SUBJECT: COMANCHE PEAK STEAM ELECTRIC STATION
EXCEPTIONS TO SER FIRE PROTECTION
COMMITMENTS

Attached are justifications for two exceptions (7a and 7b) to the use of class "A" wired detection circuits.

CABLE SPREADING ROOM
INTERACTION 7A

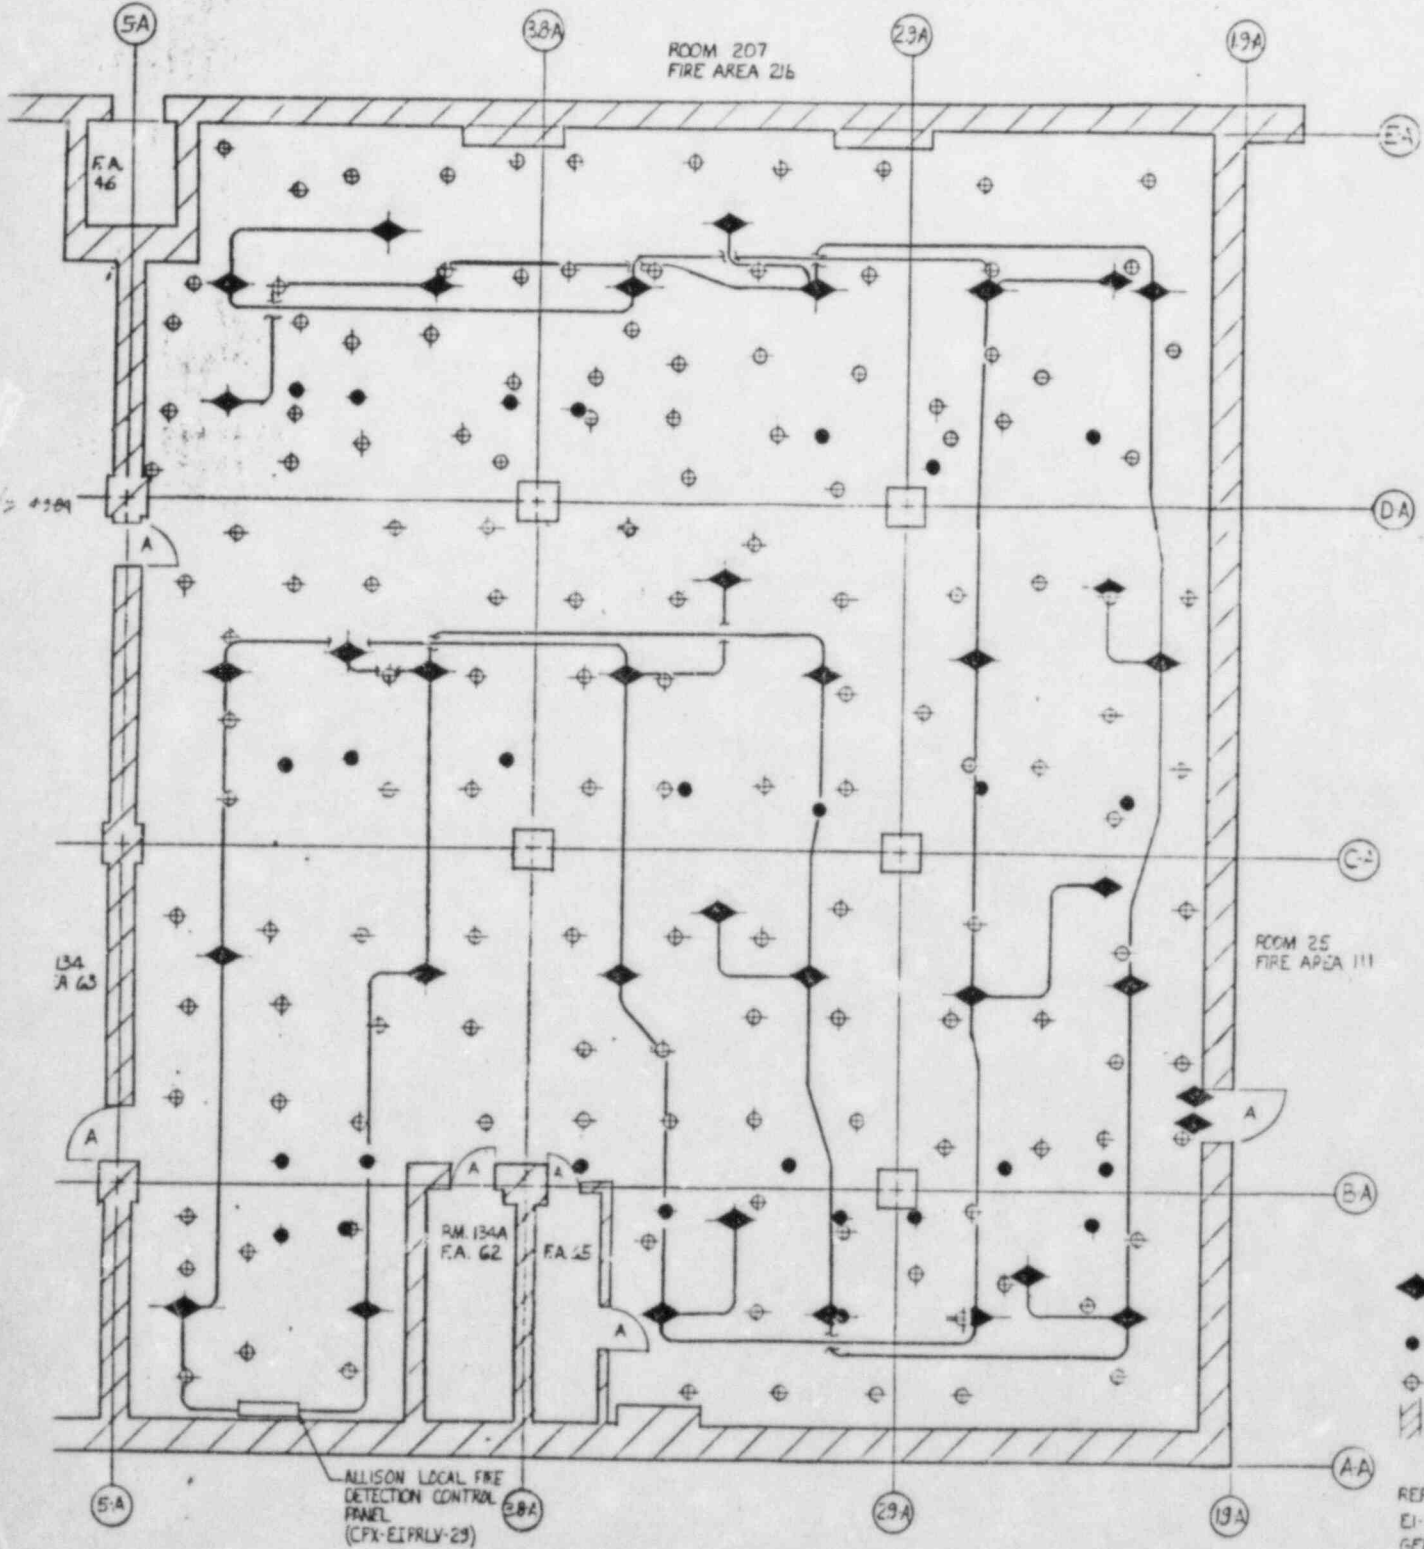
Justification:

1. An alternate dedicated shutdown system is available to bring the plant to a cold shutdown status independent of the cable spread room.
2. Class B detector circuits are provided with a trouble alarm signal annunciating in the control room for indication of a short to ground or an open circuit.
3. If a trouble alarm annunciates then Technical Specification 3.3.3.8b requires that the problem must be resolved within an hour or a fire watch patrol will be assigned to the Fire Area.
4. Manual override pull stations are available to actuate the Halon System.
5. Cross zone detection circuits are provided with two independent detection circuits that alarm in the control room.
6. A fixed water suppression system is available upon manual actuation of preaction valve.

EL. 83'-6"
INTERACTION 7B

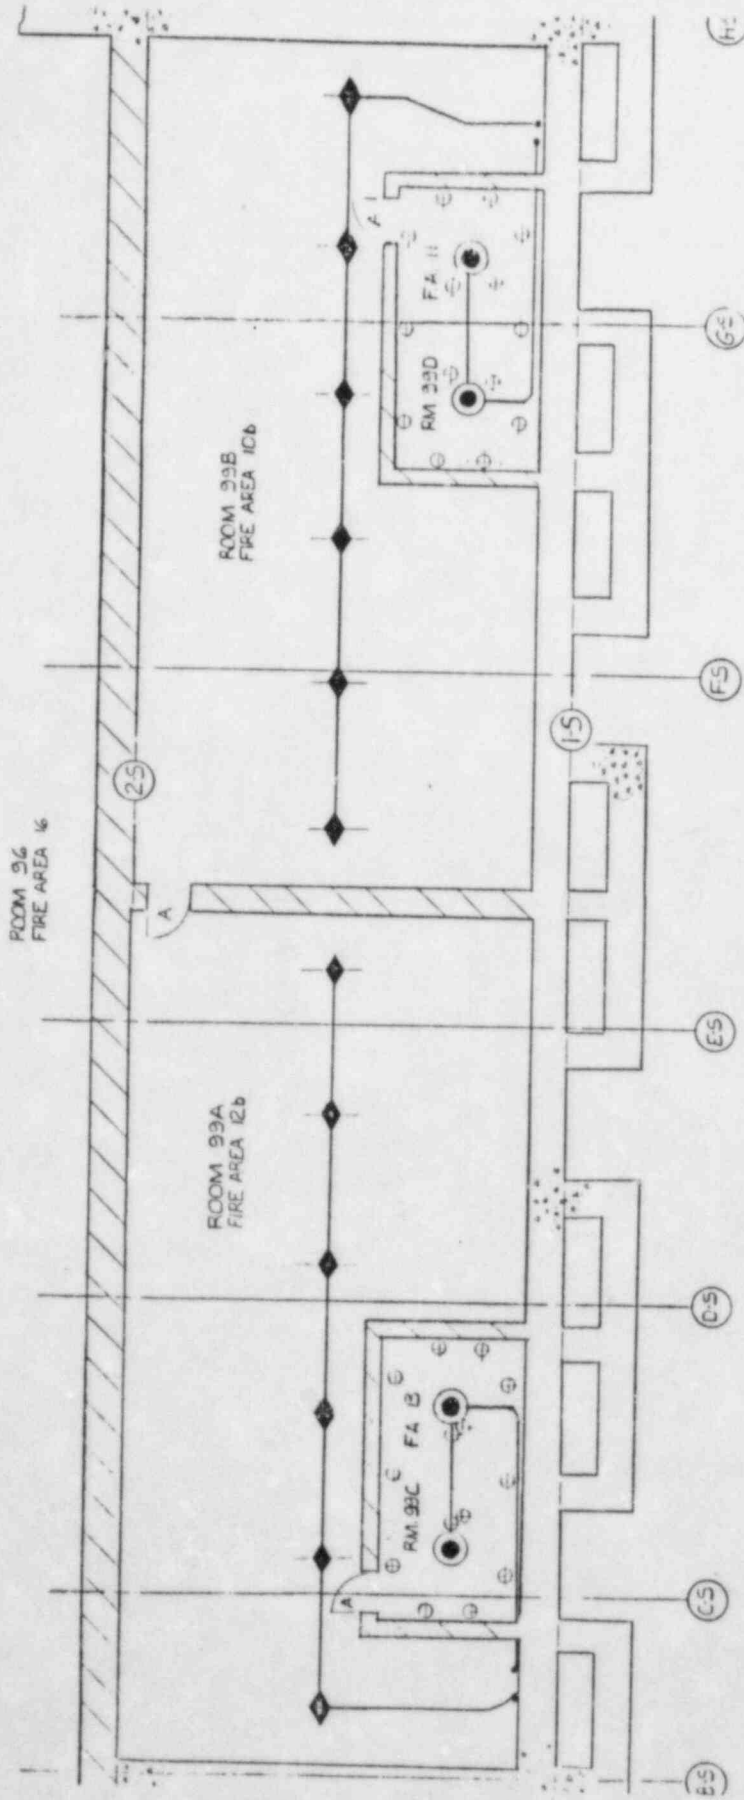
Exception: SER supplement #1 section 9.5.1.1 discusses verbal commitment to provide class A detection for all circuits that initiated suppression systems.

Description: Diesel Oil Day Tank Rooms that service the Emergency Diesel Generators are protected by a water deluge system actuated by Class B detection circuits.

Justification:

1. Class B detector circuits are provided with a trouble alarm signal annunciating in the control room for indication of a short to ground or an open circuit.
2. If a trouble alarm annunciates then Technical Specification 3.3.3.8b requires that the problem must be resolved within an hour or a fire watch patrol will be assigned to the respective fire area.
3. Manual override pull stations are available to actuate the deluge systems.
4. There is no exposure of redundant essential trains within either fire areas 10 and 11 or fire areas 12 and 13 respectively.
